PUBLIC INTEREST REVIEW FOR GROUND WATER APPLICATIONS

TO: Water Rights Section Date 11 March 2008
 FROM: Ground Water/Hydrology Section Gerald H. Grondin
Reviewer's Name
 SUBJECT: Application G-16904 Supersedes review of _____
Date of Review(s)

A. **GENERAL INFORMATION:** Applicant's Name: Valley Falls Ranch, Inc. County: Lake

A1. Applicant(s) seek(s) 4.12 (1850 gpm) cfs from 2 well(s) in the Goose and Summer Lakes Basin,
Lake Abert (Chewaucan) sub basin Quad Map: Valley Falls

Ground Water Application G-16904 Valley Falls Ranch, Inc.

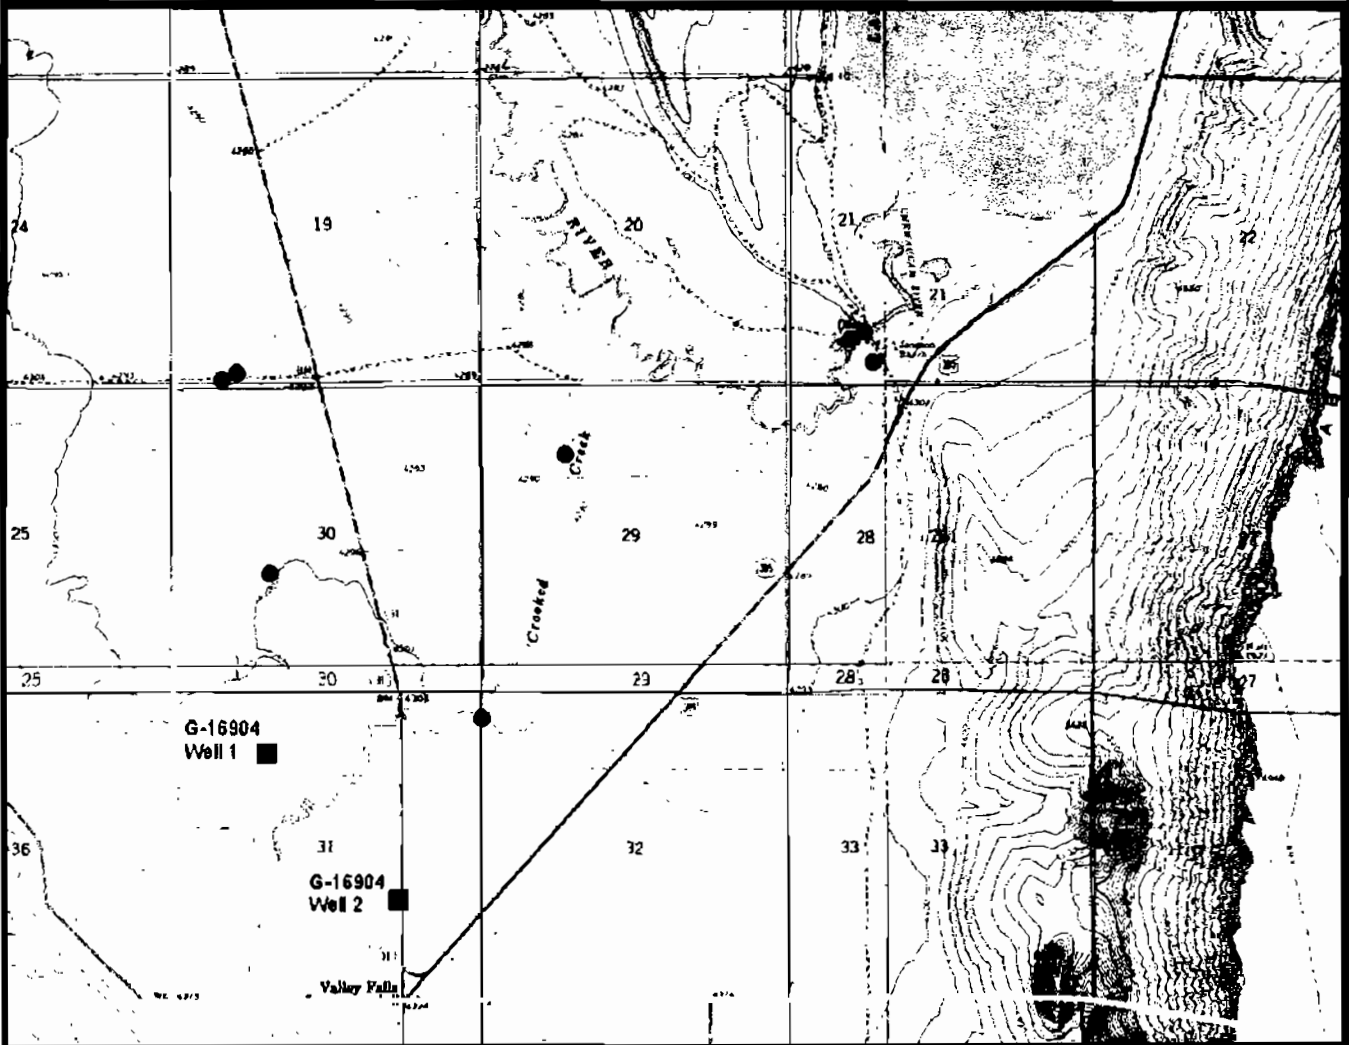
A4. Comments: The proposed wells are not yet drilled.

The proposed aquifer is alluvium. Geologic mapping (Walker 1963) indicates alluvium is limited to the Crooked Creek channel until it reaches the Chewaucan River drainage. The mapping indicates basin fill sedimentary deposits at the well sites. The proposed wells may fully penetrate the basin fill and encounter basalt at depth. Well LAKE 1769 in section 32 may have fully penetrated the basin fill (from 0 to 490 feet depth) and then drilled into basalt ("gray rock broken" from 490 to 545 feet depth, well bottom).

The proposed wells indicate first water at 240 feet depth. Water well reports for wells in section 31 indicate the first water bearing zone can be less than 50 feet below land surface.

The proposed wells indicate a static water level of 60 feet blsd. Water well reports for wells in section 31 indicate static water levels from 8 to 25 feet blsd.

**Transient Stream Depletion (Jenkins, 1970; Hunt, 1999)
Proposed Well 1 to Crooked Creek**

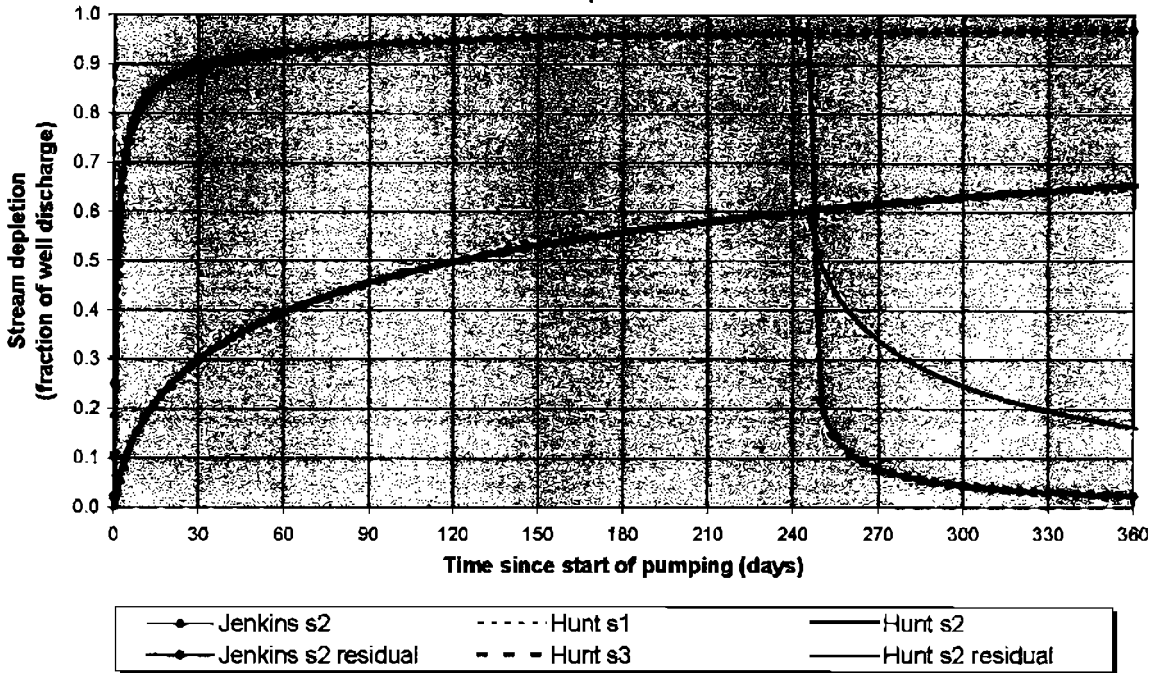
A potential for substantial interference is assumed given well 1 is less than 0.25 miles from Crooked Creek and hydraulically connected, the proposed rate of appropriation for well 1 and well 2 is greater than one-percent of the 80% natural flow, and the calculated interference with the creek is greater than 25% of the rate of appropriation at the end of 30 days for well 1 and well 2.

If a permit is issued, include conditions 7B and 7N.
